AMEC Project Number VM00448

**Reference: Mt. Polley Mine Tailings Facility
Optimization Potential – Follow Up from Dam Safety Review**

**TSF Potential Optimization Workshop
February 2007**

MOUNT POLLEY MINING CORPORATION			
MOUNT POLLEY MINE			
TAILINGS STORAGE FACILITY			
MAIN EMBANKMENT			
TYPICAL SECTION			
Knight Piesold		DESIGNED BY	REV. 11/10
		DATE	11/10
		BY	11/10
		CHKD	11/10
		APP'D	11/10
		FIGURE 2

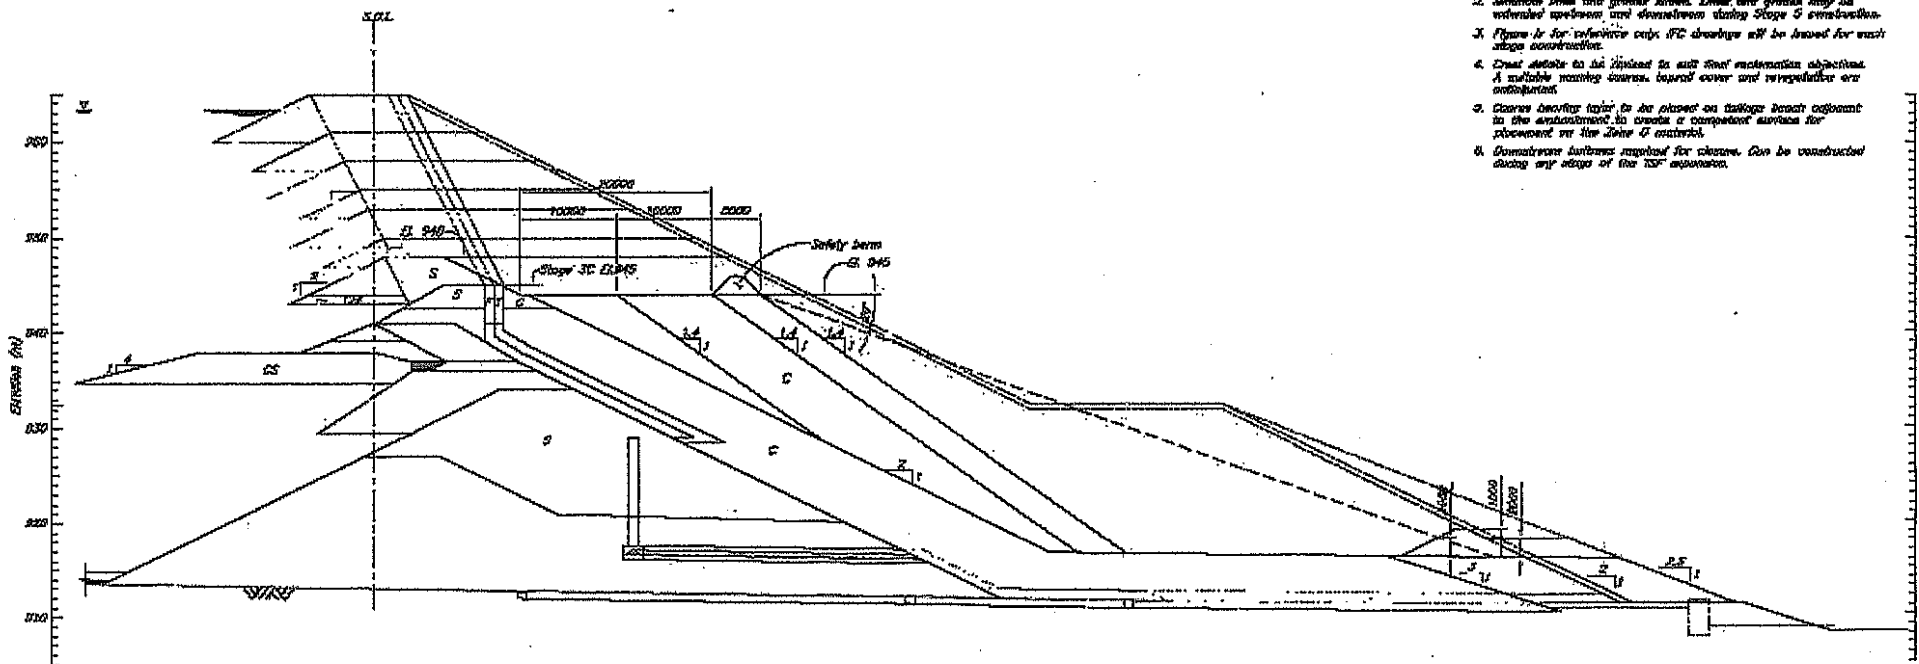
From our review we consider that there is a real opportunity to reduce the width of the core zone being stipulated for the raises moving forward. It is common dam engineering practice to narrow the core with height in the dam though there is a minimum thickness for the core (typically a practical construction consideration). The current core width of 8 m is certainly robust. Given the remaining projected height of dam construction to final elevation (assuming that the currently stipulated final elevation is not significantly exceeded), a decrease in core width should be considered for the 2007 raise and each raise thereafter. An acceptable rule of thumb is to have the core width be a minimum of 30% of the maximum head on the core; for example 20 metres of head corresponds to a 6 metre minimum requirement. The core could be further narrowed as the dam is raised in future, down to a practical minimum width of 3 m to 4 m.

- Elimination of the top 1 metre of core, above the maximum pond storage level. An impervious core is not required in this upper part of the crest that essentially only provides freeboard. This would be consistent with the design for the final dam crests at Huckleberry.
- Core alternatives such as a bituminous liner could be considered for the final few raises of the embankment section as the head will be low and confinement of such a liner is relatively straightforward to achieve.

Buttress Need

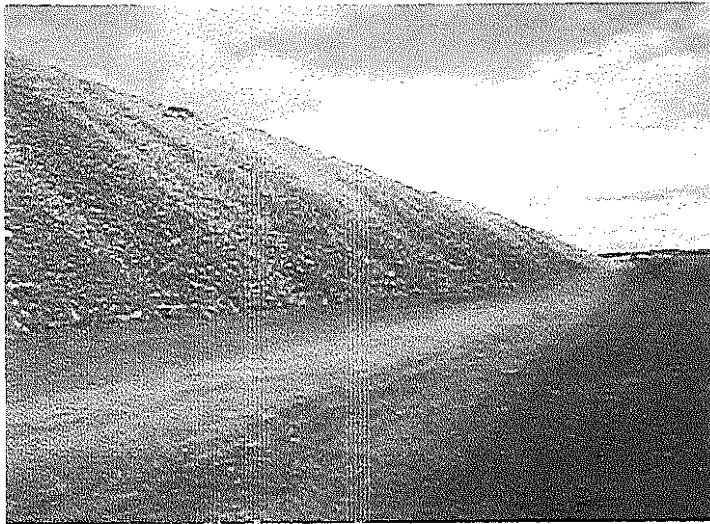
Per the 2006 DSR report, it remains unclear to us why a buttressing berm has been specified for the closure geometry of the TSF. Provided that the foundation parameters are consistent with the glacial till reported in the documents to date, there should not be a foundation concern with the existing Main Embankment Dam geometry. The foundation strength parameters indicated in design documentation for the TSF to date and the current planned geometry without a berm would result in adequate stability conditions for operations and the closure condition.

The only uncertainty is the nature of the foundation soils regarding potential presheared planes of weakness. This issue was raised during the DSR but had not been noted in previous design documentation. If there is no such concern, as above, then there would appear to be no real need for the proposed berm.

Finally, if there is a valid reason for the berm identified the berm material need not necessarily be waste rock from the mine. All that would be required is an equivalent mass and, depending upon placement and geochemical considerations, even tailings may be an acceptable berm construction material.

Pond Management

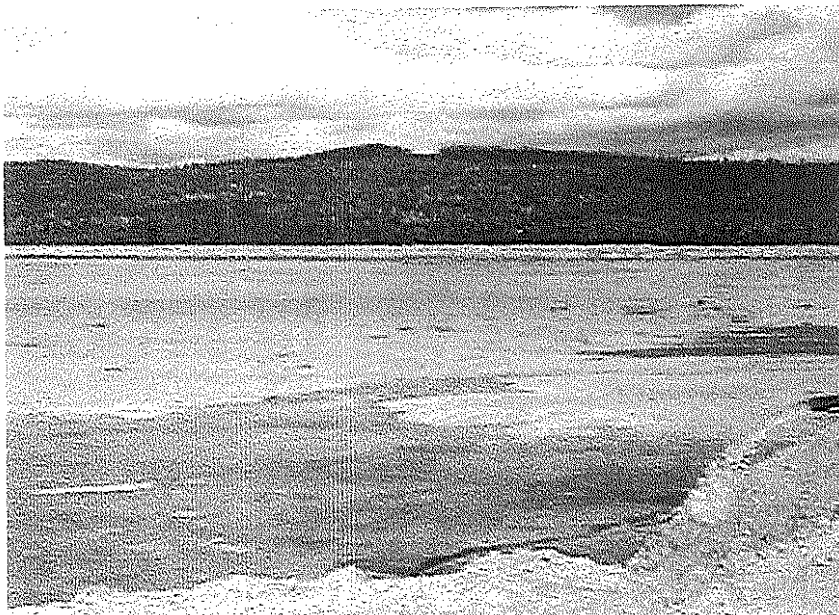
The mine maintains a comprehensive water balance for the TSF. This balance appears to be fine-tuned to an accuracy that is in the range of centimetres in terms of pond elevation. The currently stated freeboard requirement of 1.0 metres for wave runup from wind activity is excessive and could be reduced to a value readily calculable but not likely to be more than 0.3 metres. This amount of wave freeboard would then be added to the peak inflow for the chosen return period. It is likely that the operating freeboard could be reduced from 1.5 m to, say, about 1.0 m.

In terms of beach development, as long as there is not water depth to the point where the dyke raise portion that is built out in the pondward direction has instability issues, there is no rush to develop a beach on the impoundment from the Main Embankment. Further discussed below in Section 2.5, development of a beach consistent with closure expectations will eventually be required, though simply keeping the water depth to a bare minimum (not more than about one metre) should be sufficient until the last one or two lifts of the facility. This should allow some capital planning for the eventual expense of having to create a closure geometry consistent with a TSF pond spillway adjacent to the natural ground/embankment interface on either the Perimeter or South Embankments (we understand the former location is the currently preferred option).

Closure Objectives

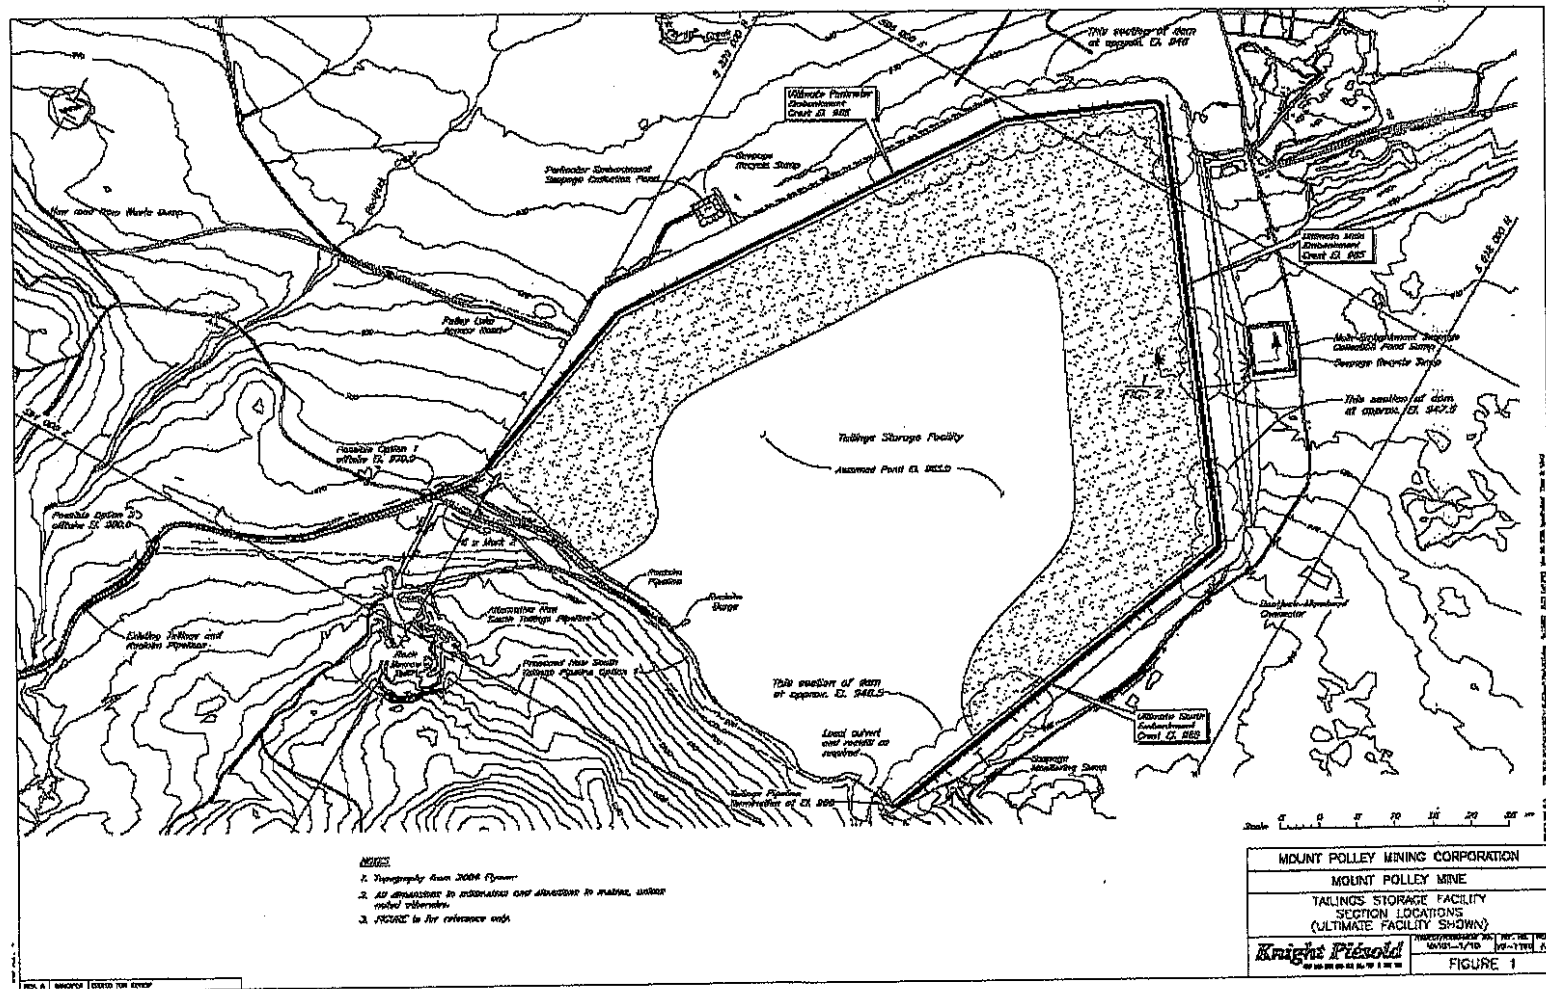
The current closure concept for the TSF is currently at odds with the way in which the pond is operating. As noted in 2.3, this is not something that requires immediate attention provided water depths at the embankments is kept to a minimum.

Finally, the conceptual layout in Figure 1 of the provided "Preliminary Design of the Tailings Storage Facility to its Ultimate Elevation" cannot be practically achieved. The nature of the manner in which tailings beaches develops is at odds with the schematic concept in Figure 1. A more realistic tailings planning exercise will be required prior to adopting a final closure plan for the TSF.
